TO: County Development Review Committee

FILE REF.: CDRC CASE # V/FDP 15-5170 Jacona Transfer Station

Santa Fe County, Applicant, requests Final Development Plan approval to allow a facility to be utilized as a County Collection Center on 19.63 acres \pm . The Applicant's request also includes a variance of Ordinance No. 2002-6, Article III, Section 4.4.4(c) (Maximum Height) to allow the structure to exceed 24 feet in height, a variance of Ordinance No. 2000-01, Section 2.3.6.d.2, to allow retaining walls to exceed 10 feet in height and a variance of Article VII, Section, 3.4.1.1.c.1 (No Build Areas) to allow 5 isolated disturbances of 30% slope for access roads totaling 1,313 square feet of disturbance. The property is located off of Highway 502, within the Jacona Land Grant, within Section 15, Township 19 North, Range 8 East, (Commission District 1).

PROJECT: **JACONA TRANSFER STATION**
 SHEET TITLE: **SLOPE ANALYSIS**

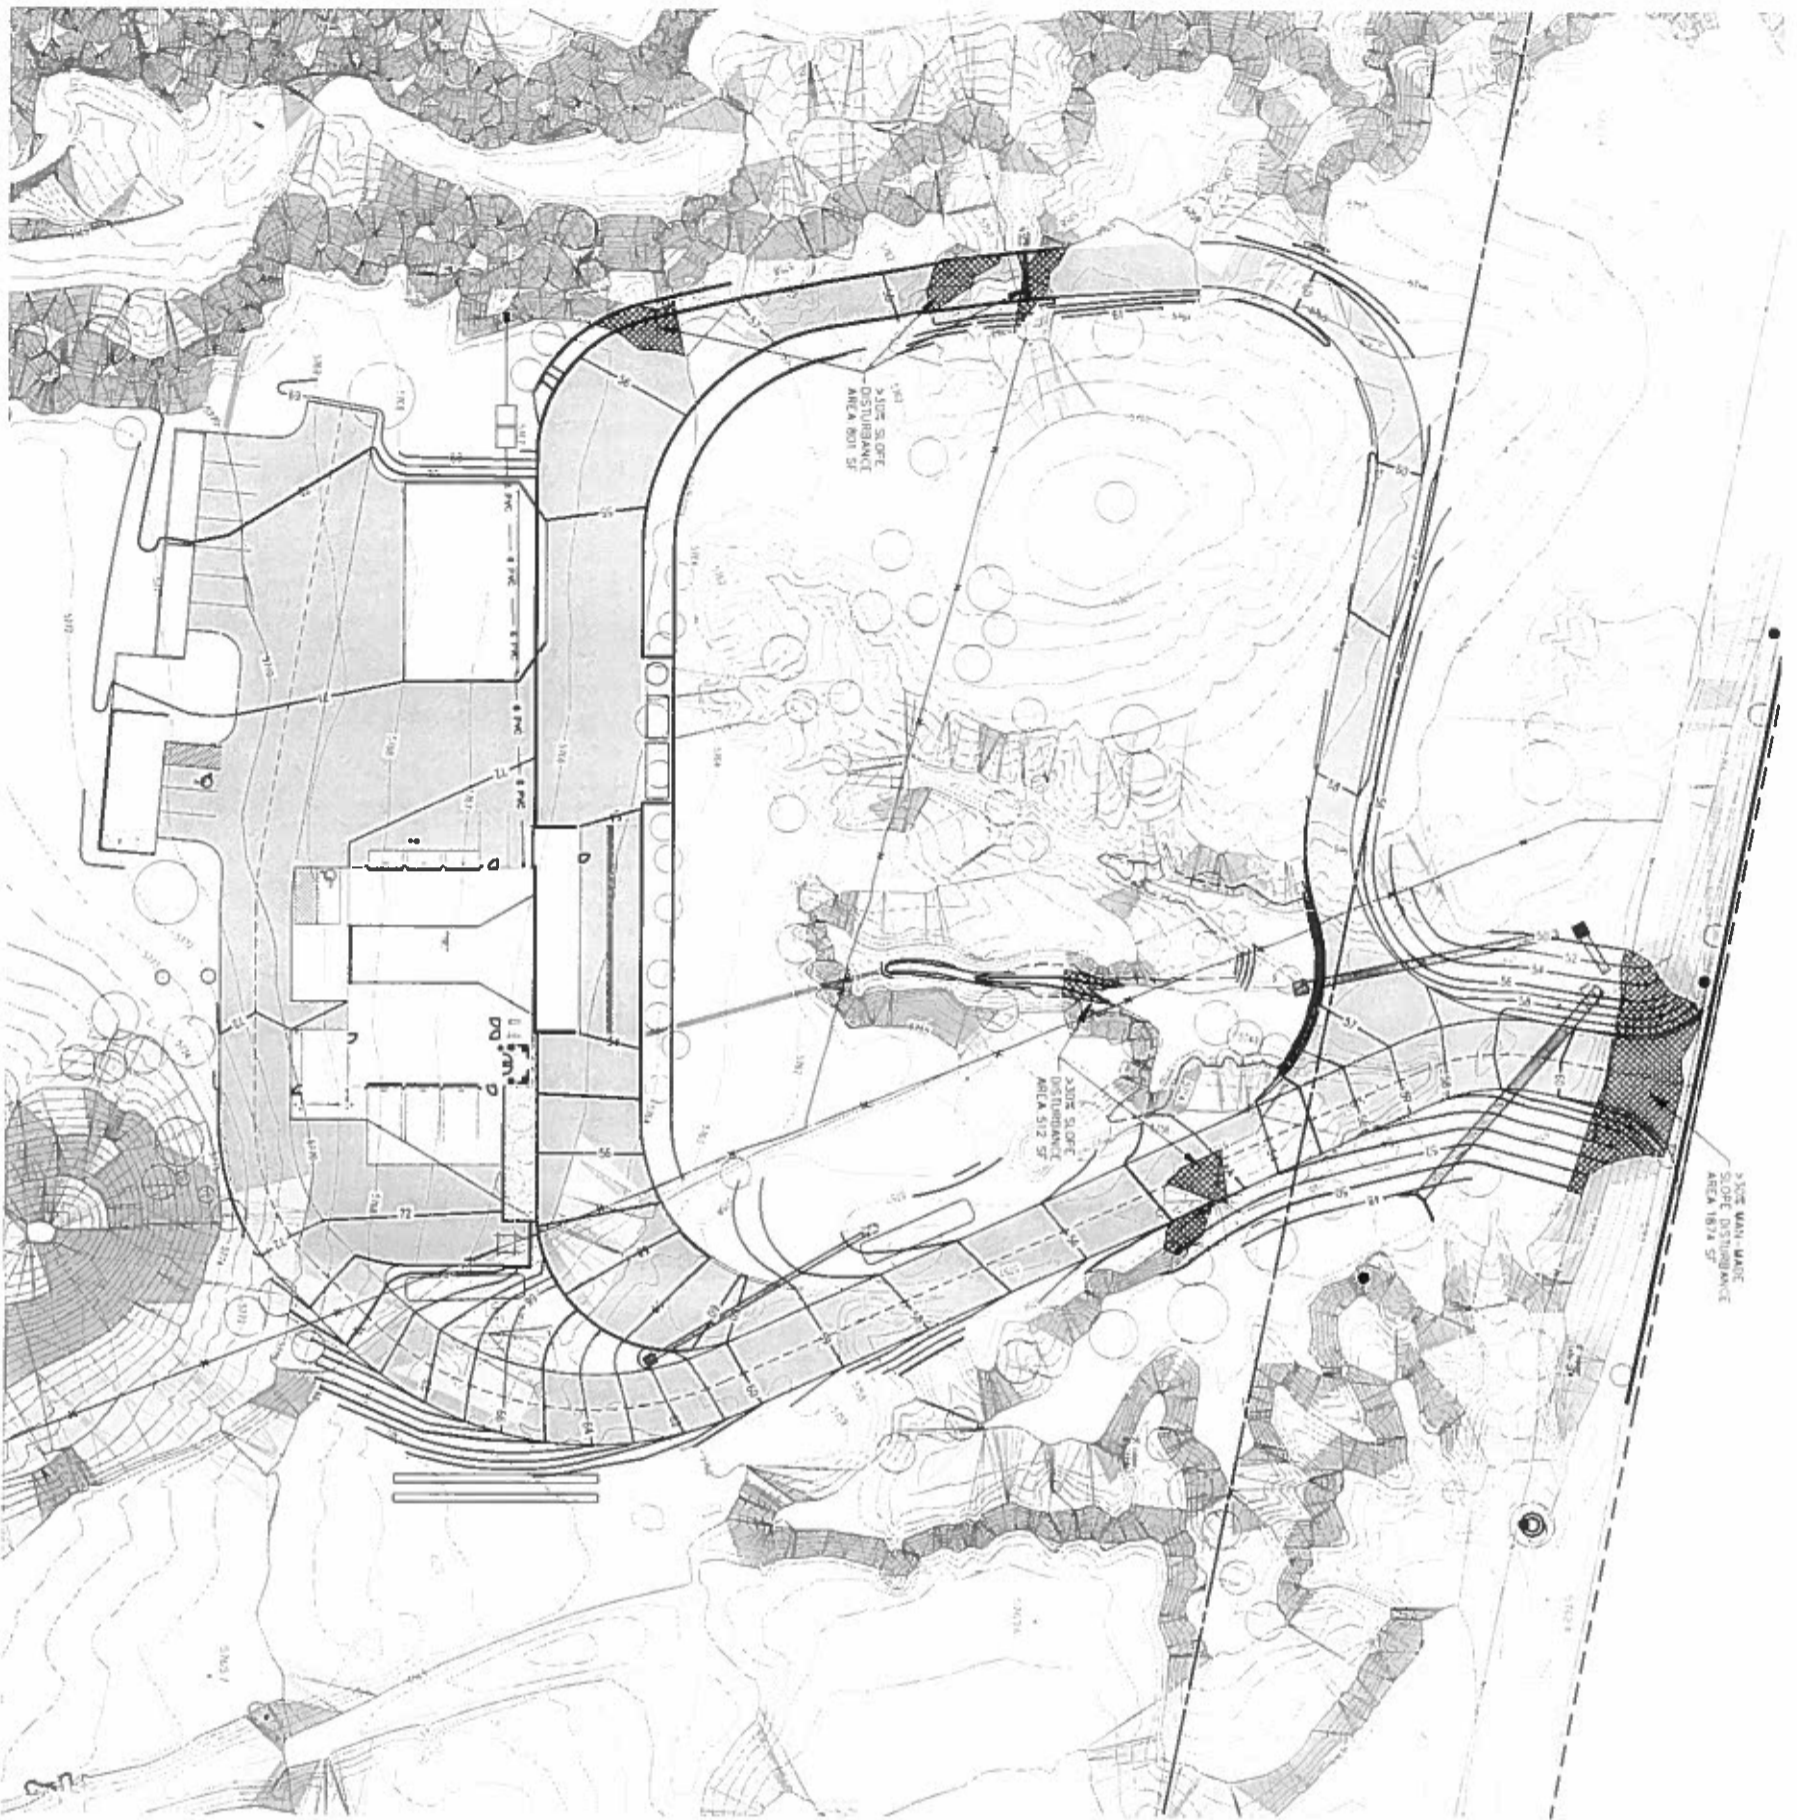
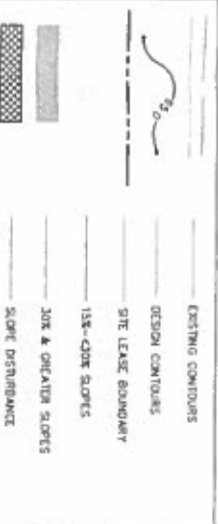
Staff Response: The disturbance of the five (5) separate occurrences of 30% slopes is minimal as the square footage of those combined disturbances totals 1,313 square feet. The disturbance of the 30% slopes is necessary to create an access that is safe not only for the general public utilizing the facility and the employees, but also creates a safe and adequate access for emergency vehicles. The disturbance of the 30% slopes will have a minimal visual impact from Highway 502.

3:10% MAX. WASTE SLOPE DISTURBANCE AREA 801 SF
 1:1 DISTURBANCE: 1074 SF
 DISTURBANCE ON NATURAL 3:10% SLOPES: 151 DISTURBANCE: 512 SF
 2:1 DISTURBANCE: 801 SF
 TOTAL DISTURBANCE: 1,313 SF

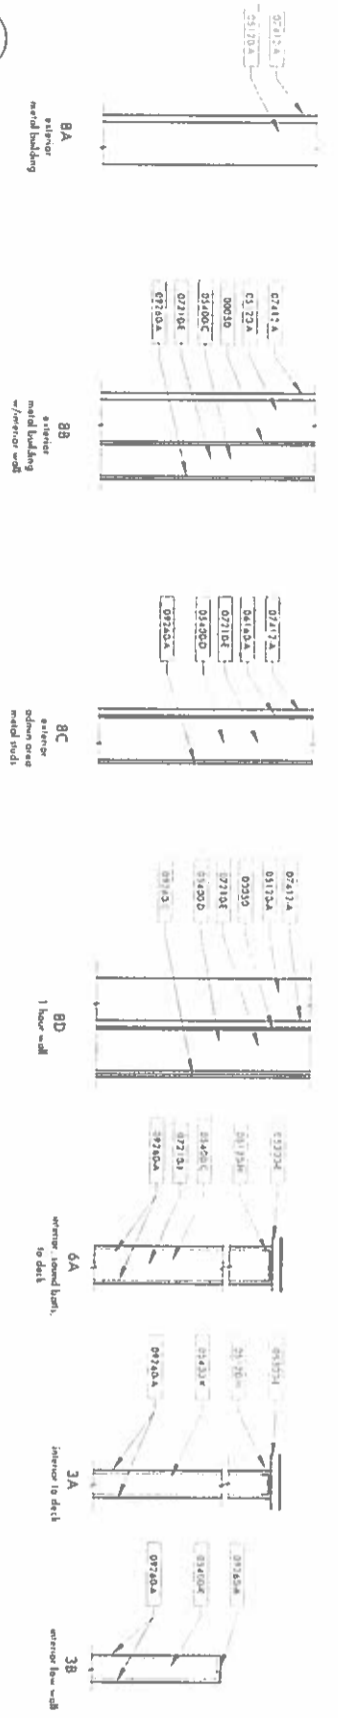
The Applicant is proposing to plant twenty (20) trees for added screening from Highway 502. The Applicant has stated that there are hundreds of trees on the site and 63 of these trees provide screening for the Collection Facility. The Applicant is proposing to utilize a drip irrigation system to water all new plantings. The Applicant is also proposing to use river rock around the trees instead of shrubs. The Applicant is proposing 11 parking spaces in total, 2 are assigned handicap parking spaces. The parking spaces will be located at the main building and reuse area. The existing landscaping along with the buildings will provide a buffer from Highway 502. This aspect of the development meets Code requirements.
